## DRI REGIONAL REVIEW FINDING

RE: Development of Regional Impact (DRI) Review

Name of Proposal: Strategic West Logisitics Center IV - Douglas Hills DRI 3515

## Douglas County Natural Resources Group Review Comments January 31, 2022

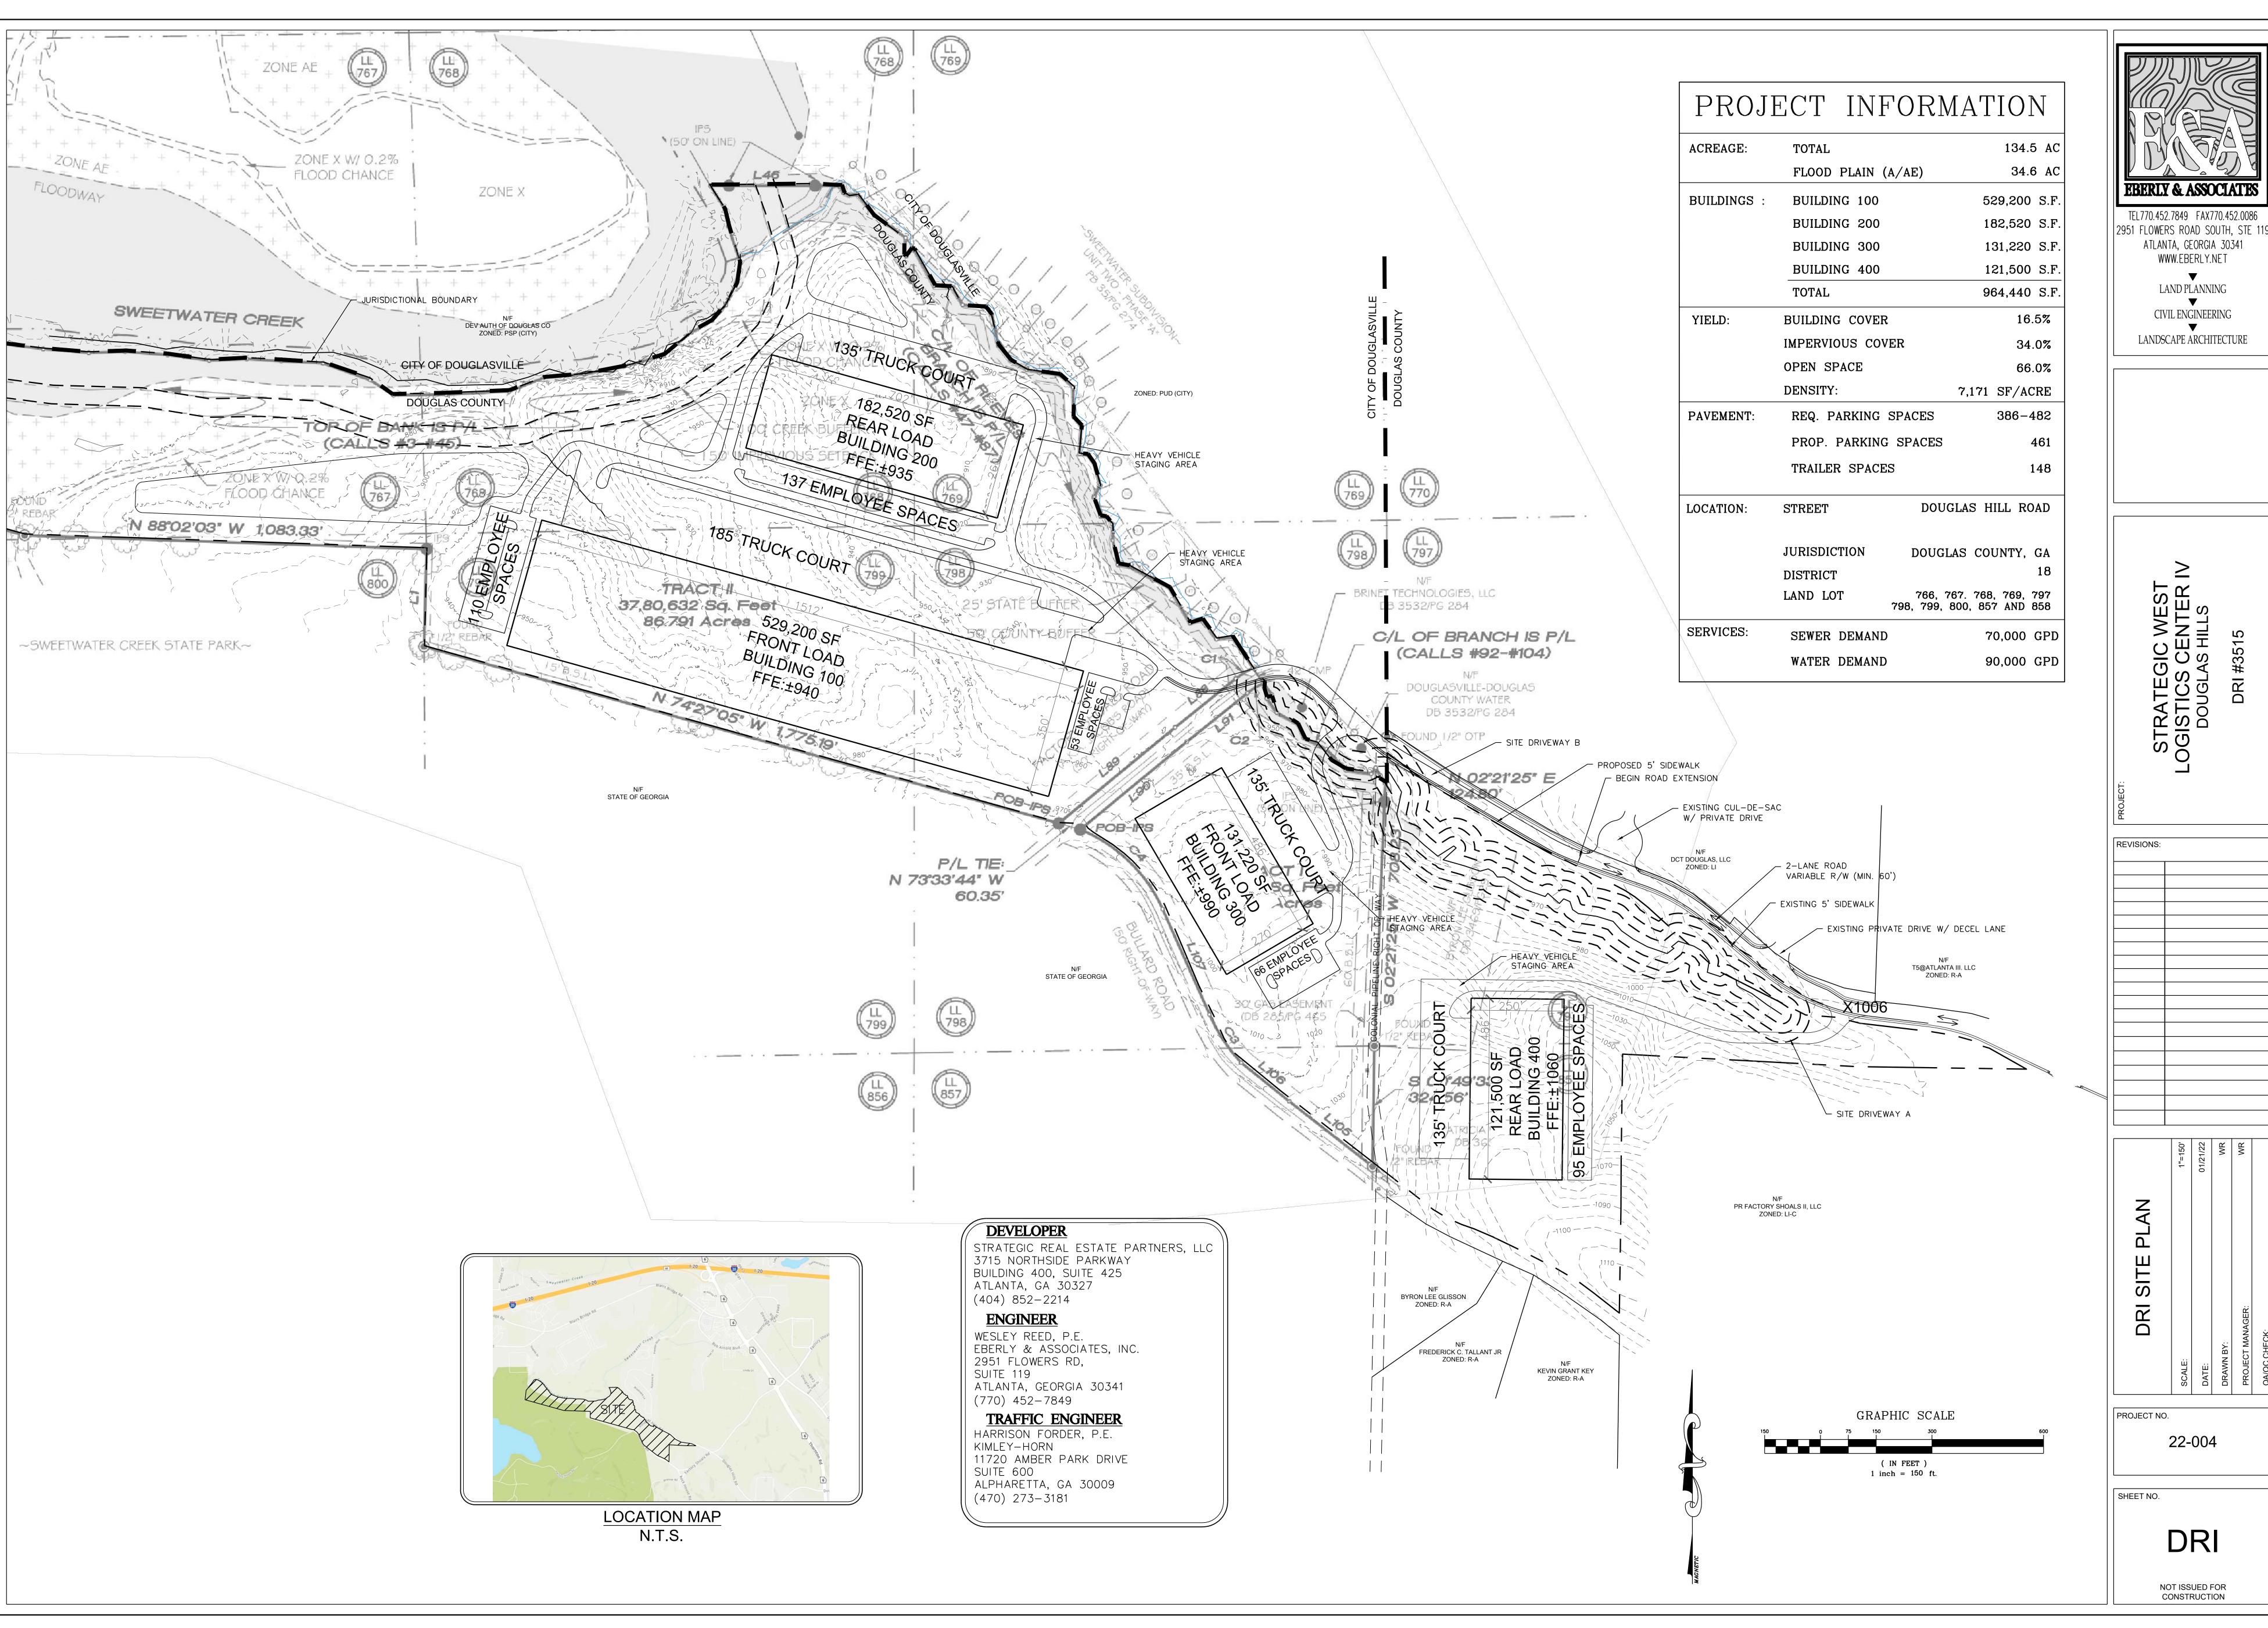
"The site plan shows and identifies the 100-foot undisturbed buffer and additional 50-foot impervious surface setback required by the County along Sweetwater Creek. However, the State 25-foot State Erosion and Sedimentation Control buffer is not shown along Sweetwater Creek. Along the tributary, it appears that the 50-foot undisturbed buffer and additional 25-foot impervious setback required by the Douglas County Stream Buffer Ordinance and the State 25-foot State Erosion and Sedimentation Control buffer are shown but not identified between the tributary headwaters and the point where an unnamed two lane road crosses the stream. Between that point and Sweetwater Creek, the 50-foout undisturbed buffer and the State 25-foot buffer are shown and identified, but the additional 25-foot impervious surface setback is not shown. All applicable buffers should be shown on the plan."

"The site plan shows driveways to Buildings 300 and 400 as well as the unnamed two lane road crossing the stream buffers. The plan also shows a portion of a driveway and part of the driveway to Buildings 100 and 200 as well as a portion of the Building 200 truck court also intrude into the tributary stream buffers. Also, a drive accessing the Building 200 truck court and an unnamed area that may be stormwater detention run up to the edge of the Sweetwater Creek 150-foot setback."

The USGS coverage for the project area and the submitted site plan both show Sweetwater Creek running along most of the northern boundary of the property. In addition, both the USGS coverage and the site plan show unnamed blue-line tributary to Sweetwater running along the northeastern portion of the property, starting entirely within the property boundaries and then running along the property boundary until it cuts across the northernmost portion of the property to flow into Sweetwater Creek. The site plan shows and identifies the 100-foot undisturbed buffer and additional 50-foot impervious surface setback required by the County along Sweetwater Creek. However, the State 25-foot State Erosion and Sedimentation Control buffer is not shown along Sweetwater Creek. Along the tributary, it appears that the 50-foot undisturbed buffer and additional 25-foot impervious setback required by the Douglas County Stream Buffer Ordinance and the State 25-foot State Erosion and Sedimentation Control buffer are shown but not identified between the tributary headwaters and the point where an unnamed two lane road crosses the stream. Between that point and Sweetwater Creek, the 50-foout undisturbed buffer and the State 25-foot buffer are shown and identified, but the additional 25-foot impervious surface setback is not shown. The site plan shows driveways to Buildings 300 and 400 as well as the unnamed two lane road crossing the stream buffers. The plan also shows a portion of a driveway and part of the driveway to Buildings 100 and 200 as well as a portion of the Building 200 truck court also intrude into the tributary stream buffers. Also, a drive accessing the Building 200 truck court and an unnamed area that may be stormwater detention run up to the edge of the Sweetwater Creek 150-foot setback.

All buffers need to be clearly identified, the 75-foot setback needs to be shown all along the tributary to Sweetwater and the 25-foot State Erosion and Sedimentation buffer needs to be shown along Sweetwater Creek.

All intrusions into the buffers may require variances under the both the County Stream Buffer Ordinance and the State 25-foot State Erosion and Sedimentation Control buffer. Any unmapped streams on the property may also be subject to the County buffer ordinance. Any unmapped State waters identified on the property may also be subject to the State 25-foot Sediment and Erosion Control buffer.
